MPD -DRB 5

RESPONSE TO BOARD COMMENTS FROM DRB 4

View of Glare from Potential Storefront Entrance

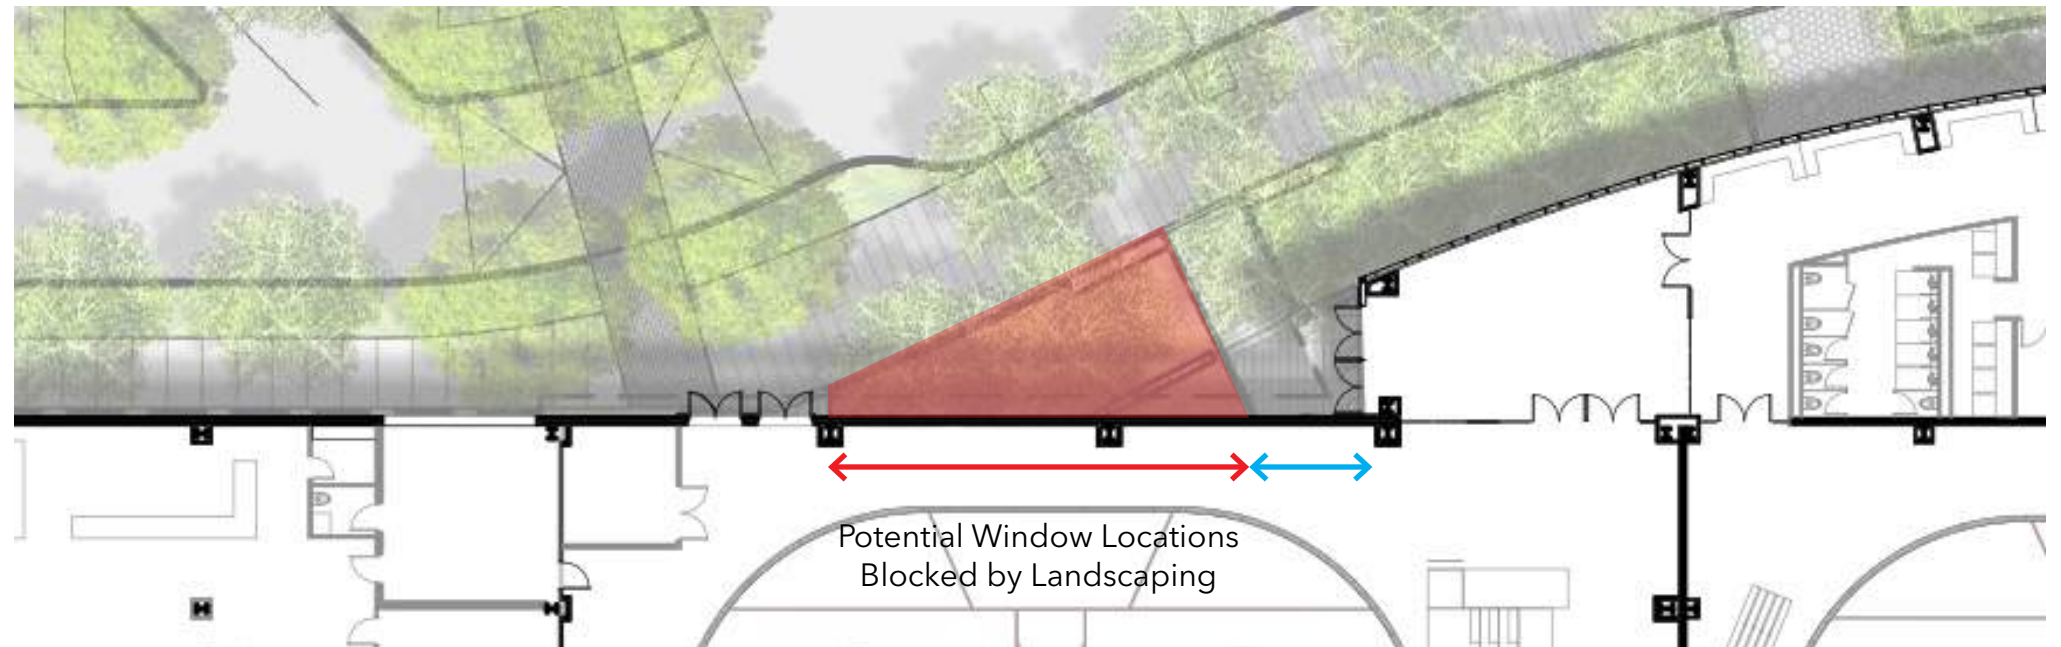
Comment: Provide View into Rink 1.

Response: Views from the sidewalk to Rink 1 via windows/glazing will create a negative visual impact for skaters on the ice. This causes an extreme bright spot surrounded by darker walls and will be at a critical location at one end of the ice that the players skate towards. This affects the player's depth perception and strain on eyes having to adjust between dark and light. This is a dangerous condition for athletes moving at a high rate of speed, and for the goalie at the opposite end of the ice looking towards that glass who could lose the puck in that extreme light/dark transition. Reference view from ice to potential glass location shown here. Additionally, NHL Seattle requires that the conditions on the ice be similar to that at the main arena. Providing exterior glazing at any location would not be in compliance.

We did explore other window locations along the east facade, but they present the same glare issue. Also, to make them approachable for viewing from the exterior it would reduce the amount of landscaping and green wall. This would adversely impact the developments green factor ratio.

CURRENT - View from the 3rd Avenue Promenade Looking Northeast

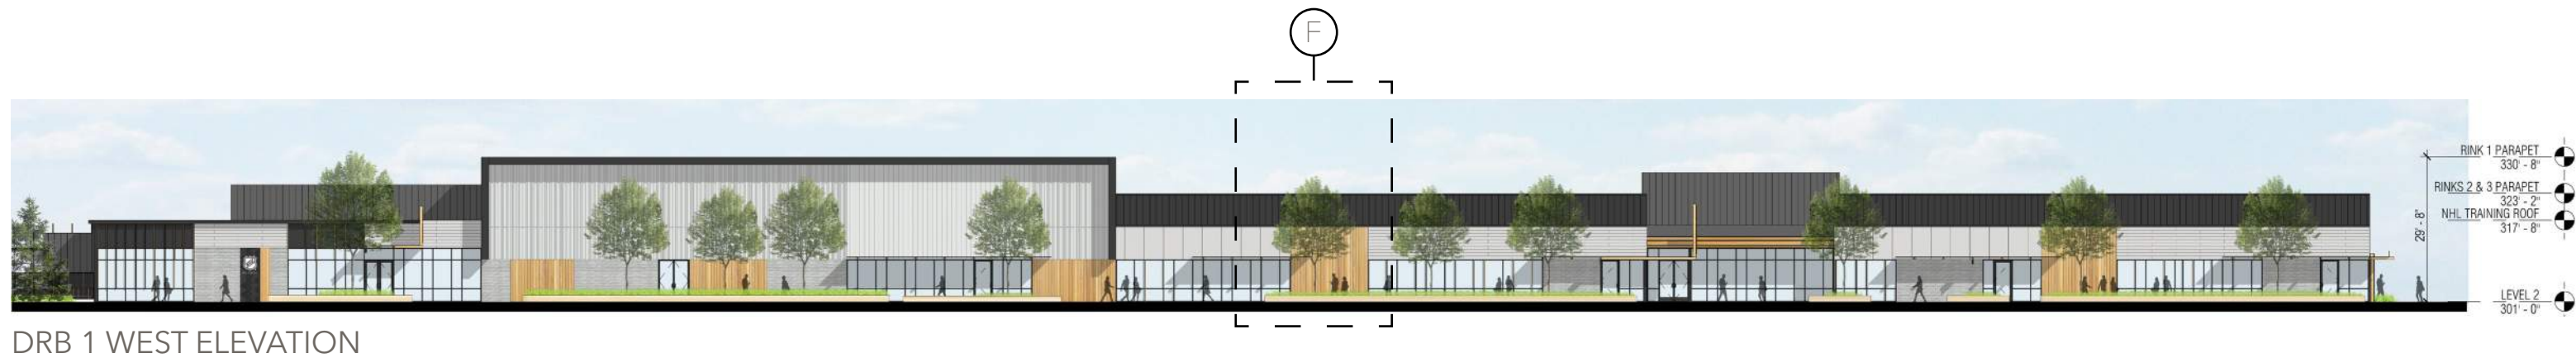
Comment: South Facade - Fenestration to treat blank wall.

Response: With regard to the Board's comments, we have redesigned the screen element along the south facade. We modified the density and spacing of the vertical slats to reflect the movement of pedestrians along the south facade within Central Park, making a sweeping gesture towards the 3rd Ave Promenade and then towards the main entry on 4th Ave NE. The solid panel at the stair integrates into the canopy, and also touches the ground to create a branding backdrop

for 'Instagram Moments.' As the screen continues east from center towards 4th Ave NE, the spacing becomes denser culminating with the screen becoming a solid platform for integrating the building signage. The varied rhythm and change in density for the wood look material is a consistent language established elsewhere around the building.

PROPOSED WEST ELEVATION

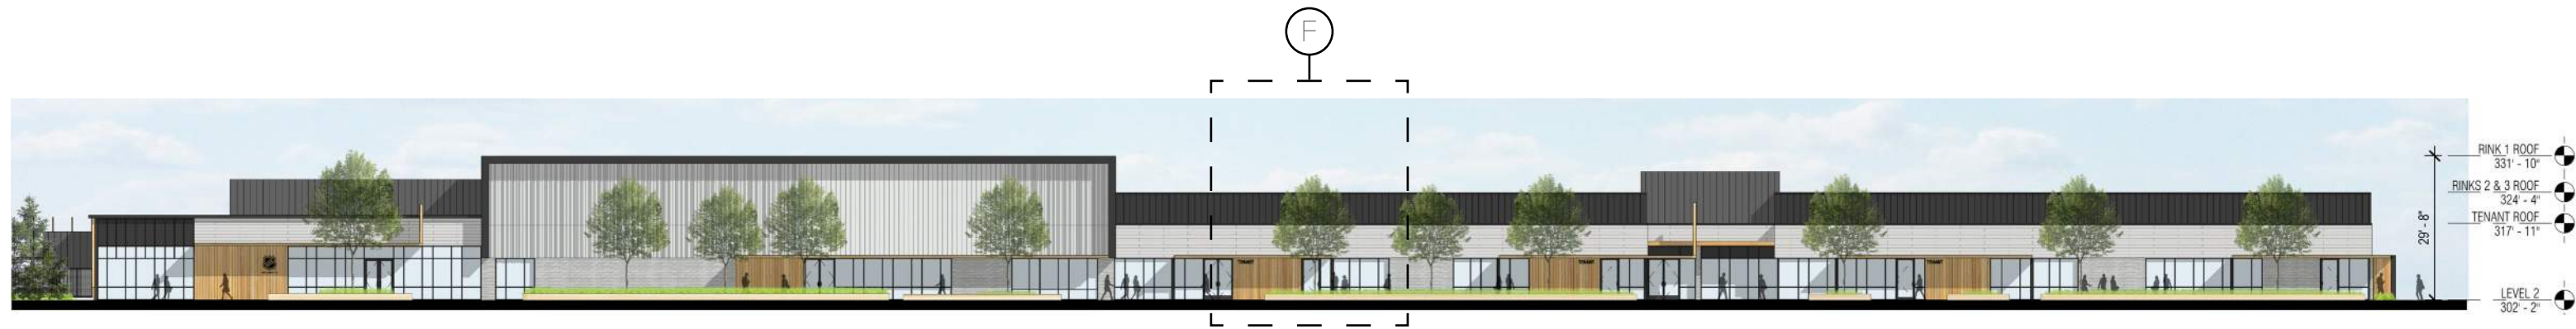
Comment: 3rd Avenue Promenade - Calm down mixed materials. Develop design language for wood material.

Response: We have rearranged the tenant spaces along the west facade to provide more opportunities for active and engaging uses along the pedestrian promenade. With the addition of the restaurant straddling Rinks 1 & 2, sliding glass doors will allow cafe style seating to spill out to the promenade. The wood look material on the west facade is used for signage integration and to provide relief for the pedestrian experience via canopies along west facade. The slat width/density is varied, with wider spacing at locations where no signs occur,

and denser spacing where tenant signs are proposed. This language is consistent on all four elevations including the revised design for the south elevation. The locations of the wood look material have shifted, becoming the anchor next to the main door at tenant spaces while transitioning into the canopies above. To further simplify the design, we eliminated the second type of cementitious cladding previously proposed above the storefront, and are stopping the wood sections along the facade at a consistent height.

Alternate Lobby Study with Secondary Entry + Vestibule

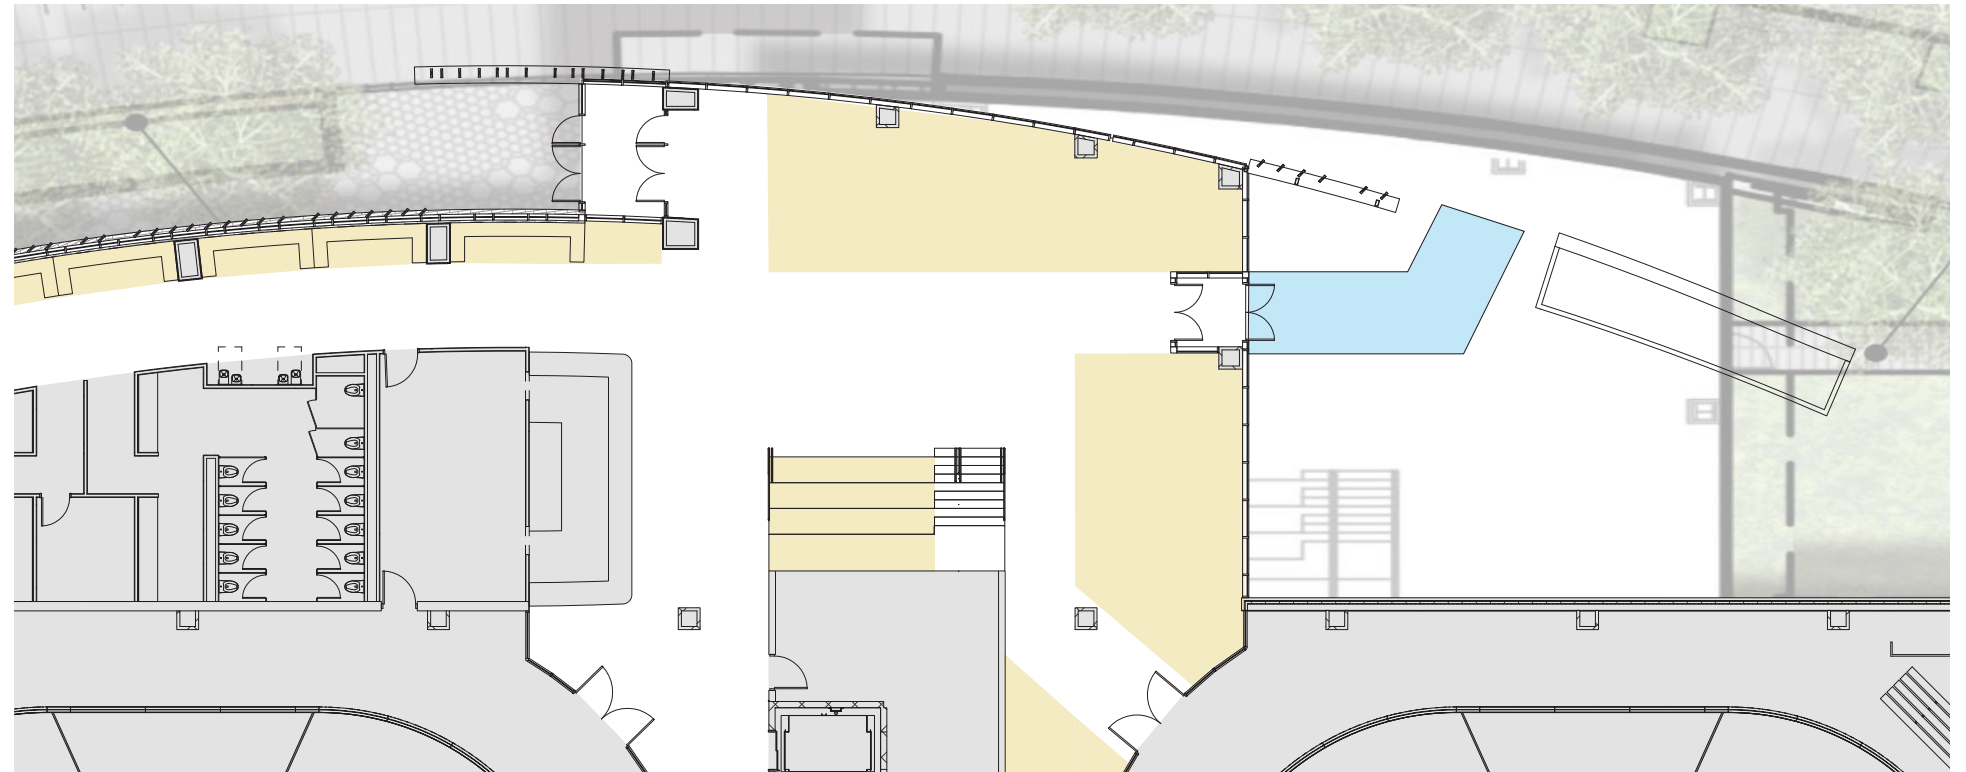
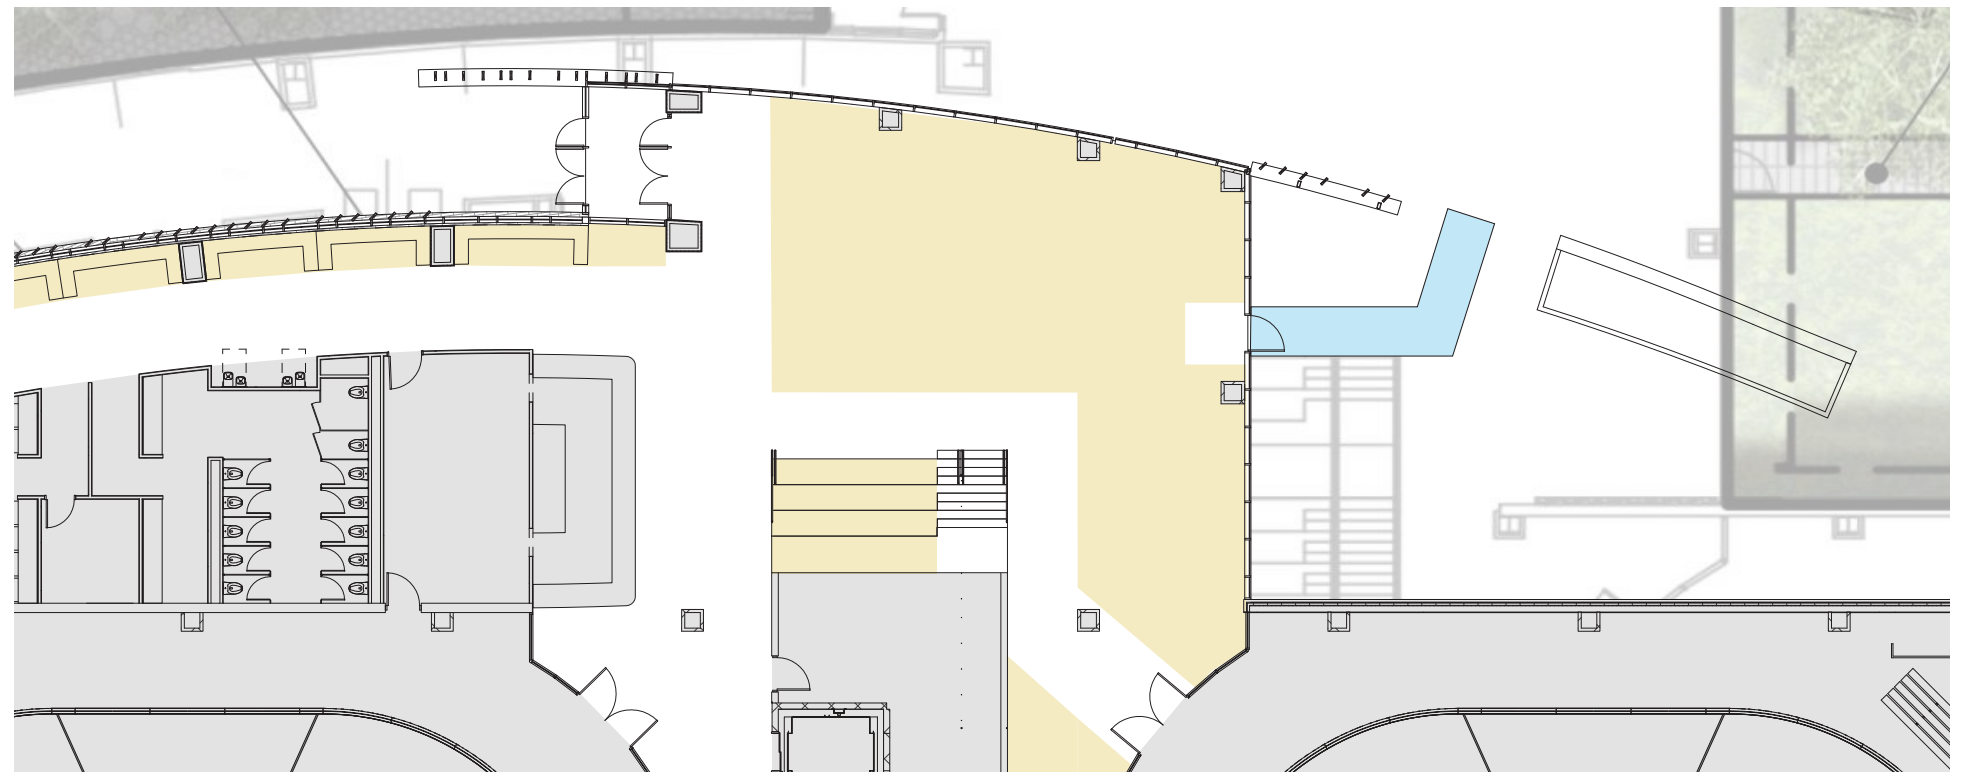
Comment: SE Entry - Redesign entry sequence; make entry grander from park and deal with bioretention limiting this opportunity.

Response: The entry sequence as proposed in DRB 4 was carefully designed to address site conditions, security, and maximizing the availability of lobby space.

Our analysis of a second entry in the lobby finds several issues. First, we are required to add a vestibule per Seattle Energy Code C402.5.7. Second, the clear path needed from the service desk and stairway area to this vestibule eliminates 560 SF from the 5,250 SF of programmable lobby space. This renders an already low square footage building less functional than others in its class. By way of comparison, the new St Louis Ice Center (3 indoor sheets) has 12,750 SF of lobby space. Third we lose 130 SF of bioretention to the south of the lobby to increase the size of the sidewalk.

The lobby area will see multiple ice sports teams seeking places to sit as a team, combined with parents and families and the general public. Maximizing the flexibility of the space through ample square footage and flexible seating arrangements is paramount. A reduction in available square footage for seating minimizes the functionality of the lobby.

Another factor considered for the DRB4 entry sequence and design is building security. Additional burden is put on staff to manage another set of doors, leading to safety concerns for our patrons and athletes.

For these reasons, we respectfully ask the Design Review Board to reconsider this request.
